HIGHGATE NEWTOWN COMMUNITY CENTRE

ACOUSTIC EMPLOYER'S REQUIREMENTS

Acoustics Report A973 R05A

Appendix B – Marked Up Drawings with Acoustic Requirements

job title	HIGHGATE NEWTOWN COMMUNITY CENTRE		
drawing title/location	BLOCK B - THIRD FLOOR PLAN - AS PROPOSED		
scale	1 : 50 @ A1	1:100 @ A3	
suitability	status description S4 - For Approval		
job no	originator	zone	level
HNCC - RCK - 04 - 03 - DR - A - 41003			
rate	dwg no	revision	
		P3

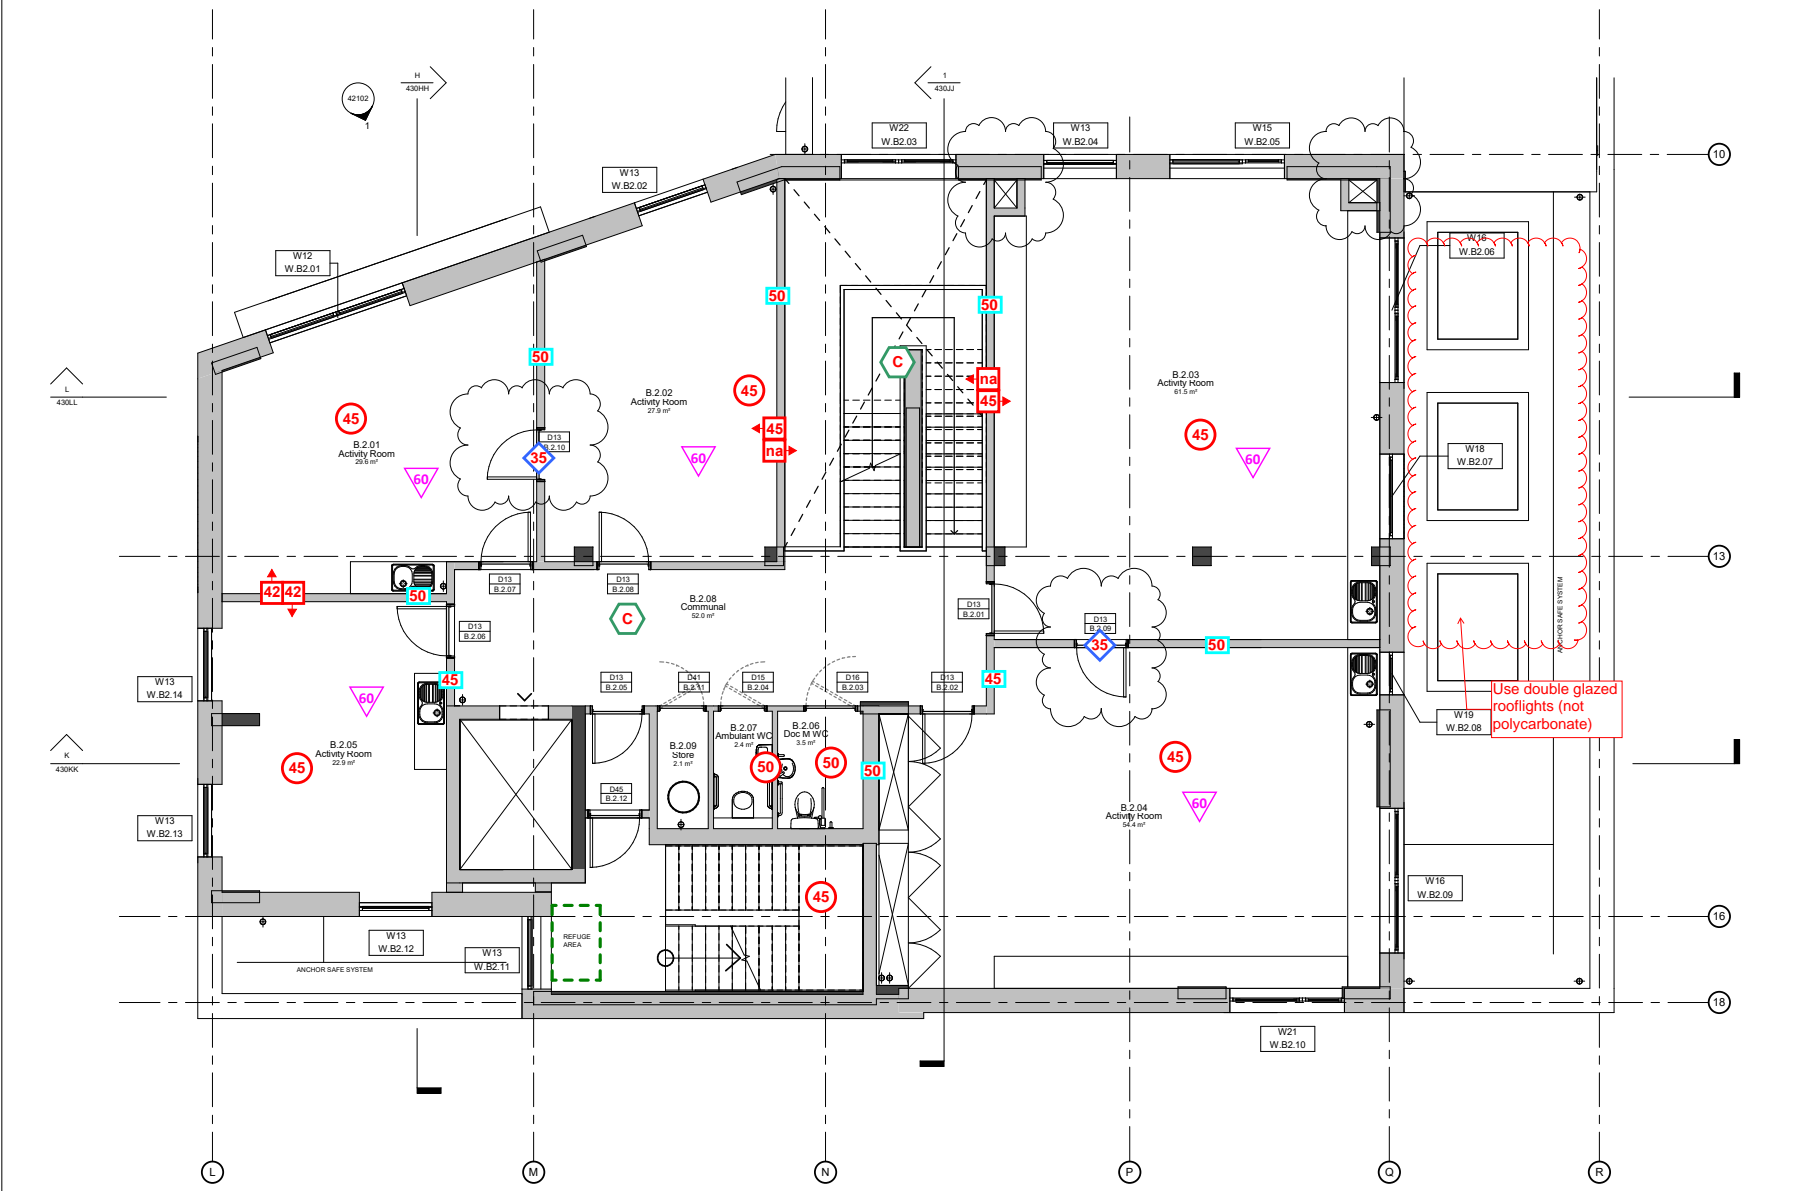
Use double glazed rooflights (not polycarbonate)

job title HIGHGATE NEWTOWN COMMUNITY CENTRE			
drawing title/location BLOCK D & STORES - GROUND FLOOR PLAN - AS PROPOSED			
scale	1 : 50 @ A1	1:100 @ A3	
suitability	status description S4 - For Approval		
job no	originator	zone	level
HNCC - RCK - 06	GF - DR - A	61	000
dwg no	revision		
	P2

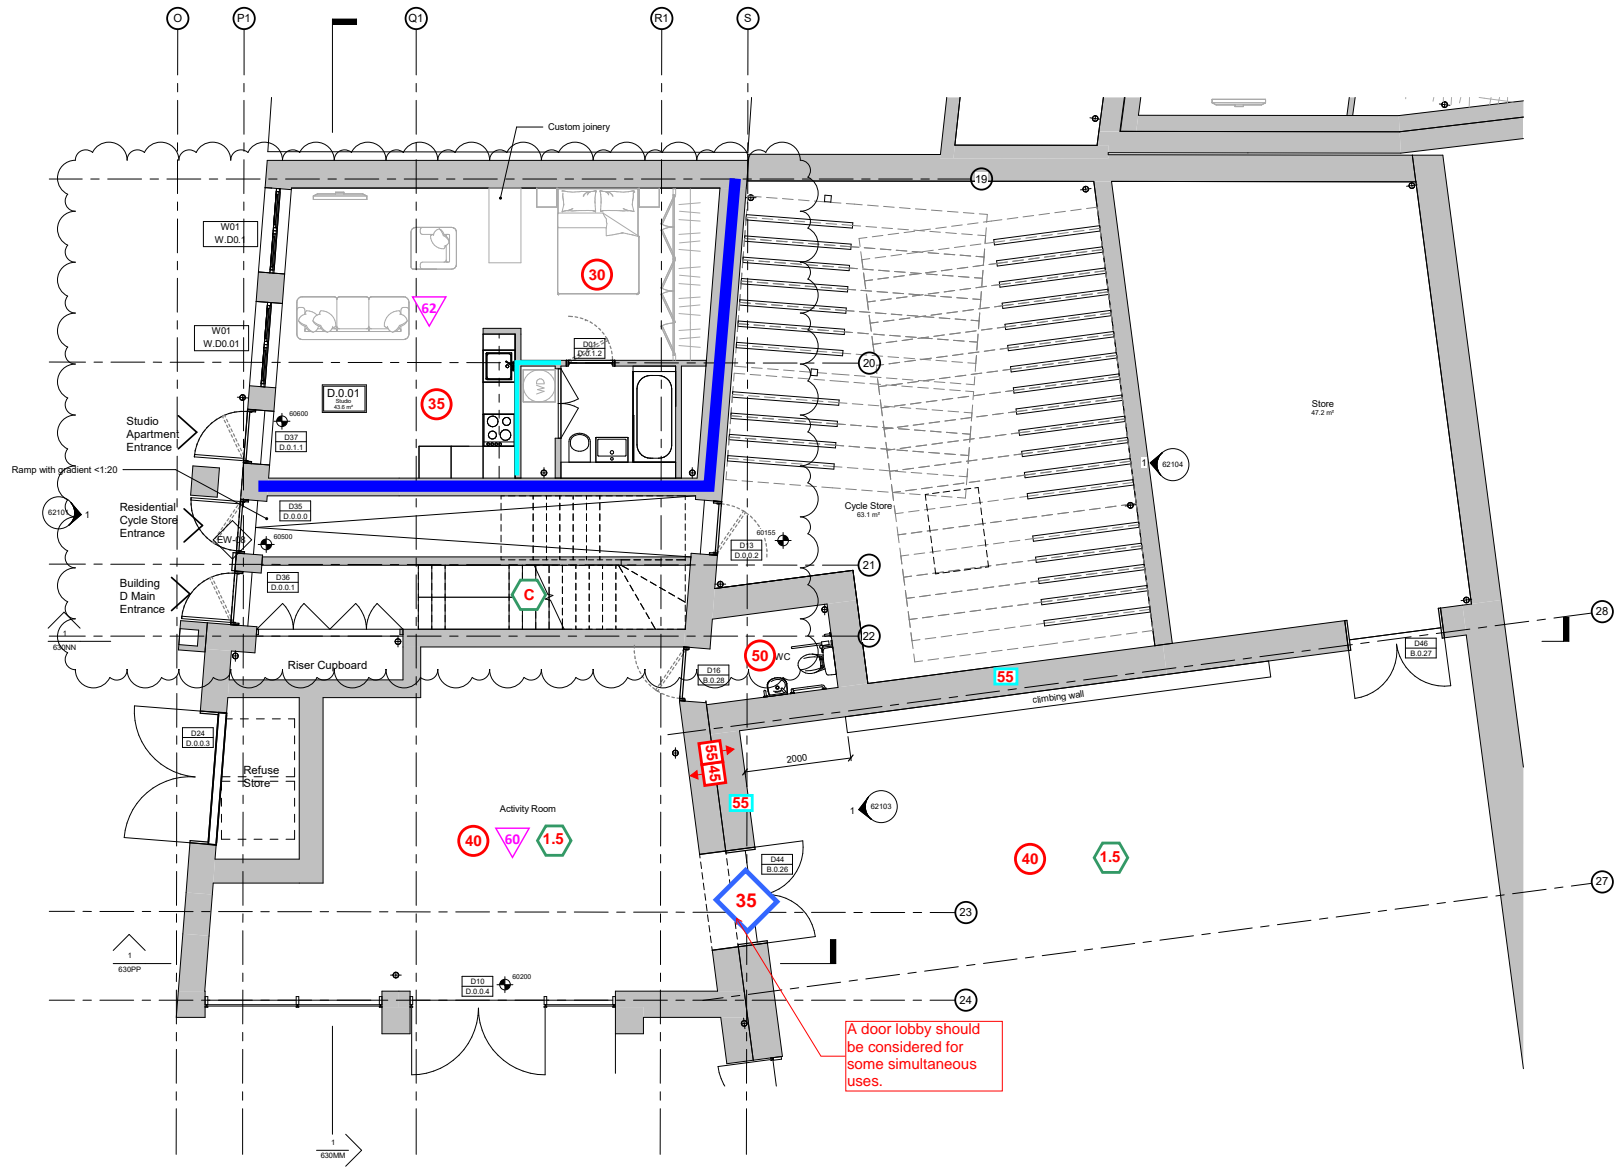
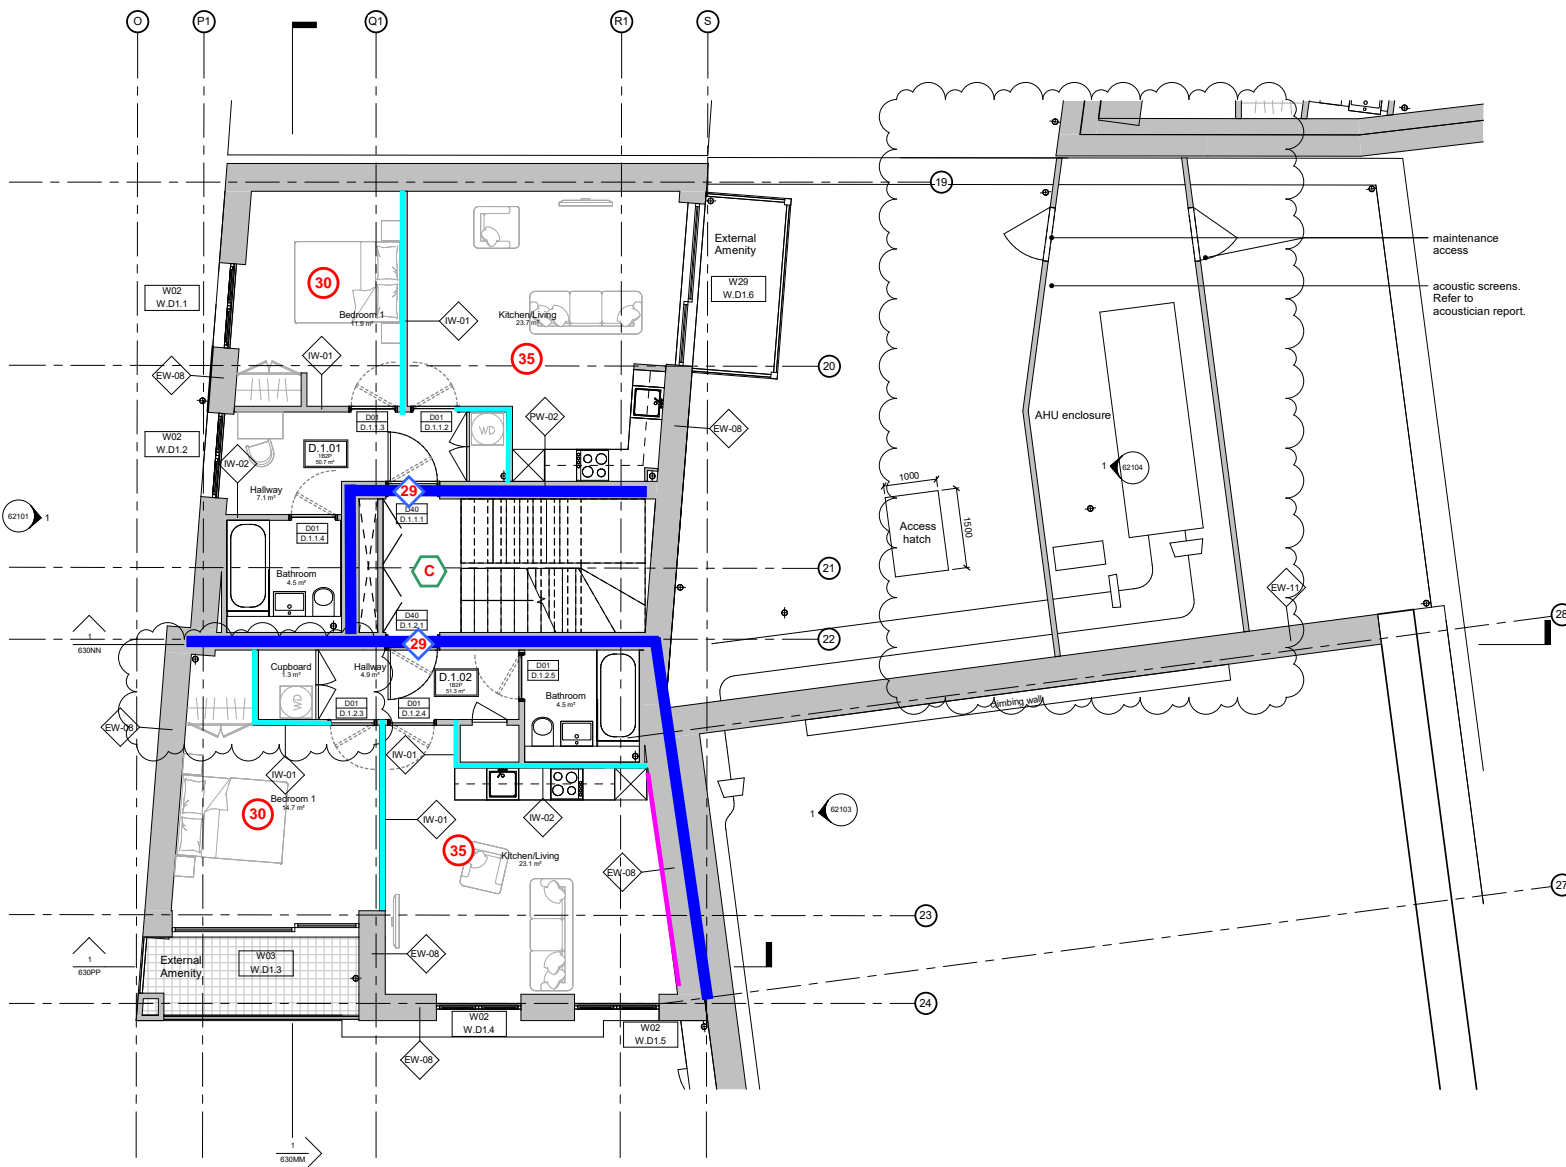
A door lobby should be considered for some simultaneous uses.
